Access Compliance Report

Public Rights-of-Way

Intersection ID: N/A	Main Street: WINDSOR_GATE_LN	Cross Street: W_T_HARRIS_BV	Location: SE
ADA ID: C2D9E9EF7D04	Ramp Type: PerpDiag	Initial Pass/Fail: Fail	Overall Compliance: No
Severity Score: 37.5			
Codes/Mitigation Info/Possible Solution		Field Measurements/Component Compliance

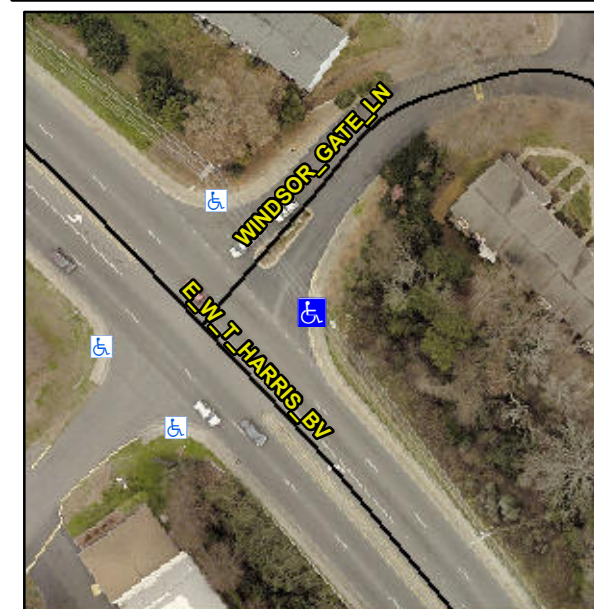
Not Found, R304.2.2, R304.5.3

Compliance	Description	Data	Compliance	Description	Data
N/A	Ramp Length (in)	60.0	No	Ramp Slope (%)	11.0
Yes	Ramp Width (in)	89.0	No	Ramp XSlope (%)	9.2
N/A	Flare Type LT	N/A	N/A	Flare Type RT	N/A
N/A	Flare Slope LT (%)	N/A	N/A	Flare Slope RT (%)	N/A
N/A	Flare Traversable LT?	N/A	N/A	Flare Traversable RT?	N/A
N/A	Landing Length (in)	N/A	N/A	DWS Provided?	N/A
N/A	Landing Width (in)	N/A	N/A	DWS Contrast?	N/A
N/A	Landing Slope (%)	N/A	N/A	DWS Length (in)	N/A
N/A	Landing X Slope (%)	N/A	N/A	DWS Full Width?	N/A
N/A	Landing Curb? (Y/N)	N/A	N/A	DWS Offset (in)	N/A
N/A	Shared Landing?	N/A			
N/A	Gutter Ponding?	N/A	N/A	Gutter Slope (%)	N/A
N/A	Gutter Lip Ht (in)	N/A	N/A	Gutter X Slope (%)	N/A
N/A	Painted X Walk1?	No	N/A	Painted X Walk2?	No
	X Walk 1 Direction	To NW		X Walk 2 Direction	To SW
N/A	X Walk 1 Width (in)	N/A	N/A	X Walk 2 Width (in)	N/A
	X Walk 1 Slope (%)	0.4		X Walk 2 Slope (%)	6.3
	X Walk 1 X Slope (%)	6.7		X Walk 2 X Slope (%)	1.9

Remove & Replace Curb Ramp With Two New Directional Ramps or Equivalent.
